Application for Licence Amendment

Licence Number	L9102/2017/1
Licence Holder	Chevron Australia Pty Ltd
ACN	086 197 757
File Number	DER2017/001839
Premises	<p>Gorgon LNG Project</p> <p>Part of Crown Lease L077431, Certificate of Title Volume LR3168 Folio 315, Site 1 on Deposited Plan 409277; Part of Crown Lease L077428, Certificate of Title LR3158 Folio476, Site 5 on Deposited Plan 64220; Temporary Wastewater Injection Facilities Licence LIC00554/2009_1_43; Part of Revised Service Corridor Easement L641372, Certificate of Title Volume LR3142 Folio 58, Deposited Plan 91514; Part of Construction & Operations Support Infrastructure Licence 00058/2014_A4735851; Permanent Water Disposal Wells Licence L00016_2012/1_A1991085; Part of Road Infrastructure Licence Lic 00565/2009_1_31; CO2 Injection System Pipeline Easement L819294; Part of CO2 Injection Wells System Licence LIC_00564_2009_A1744377; and Support Infrastructure Licence (Old Airport East) 00333-2016_A6042022</p> <p>BARROW ISLAND WA 6712</p> <p>As defined by the Premises maps attached to the Revised Licence and coordinates in DWER document: DWERDT940930</p>

Date of Report	25 July 2024
Decision	Revised licence granted

Figure 1: Proposed premises boundary additions

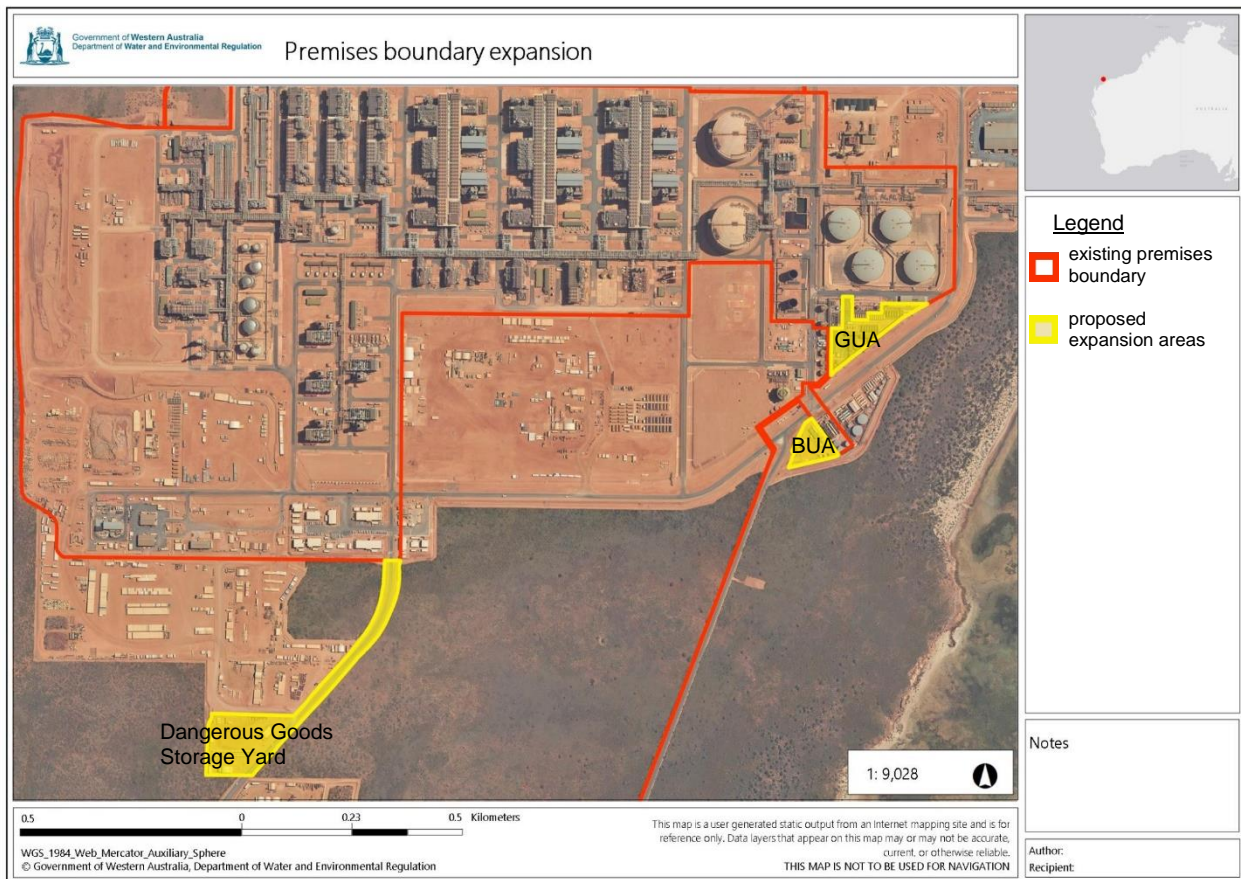
CAPL has proposed to expand their premises boundary by incorporating three adjacent areas that have been exised from the premises boundary of the Barrow Island Oil and Gas facility licence L4467/1972/14 also held by CAPL. The addition of part of the General utilities area (GUA) is to accommodate for a new WWTP authorised under works approval W6772/2023/1. Additionally, the incorporation of the bridging utilities area (BUA) and Dangerous Goods Storage Yard areas to more appropriately reflect areas where waste is generated, handled and temporarily stored prior to relocation to the waste transfer station. These additions can be seen in yellow in Figure 1 below.

Additionally, the delegated officer has amended the premises boundary to include the three proposed areas; the Bridging utilities area, General utilities area and the Dangerous goods storage yard area. These areas have been excised from the premises boundary of licence L4467/1972/14 for the Barrow Island Oil and Gas Facility and now fall within the operational control of the Gorgon GTP.
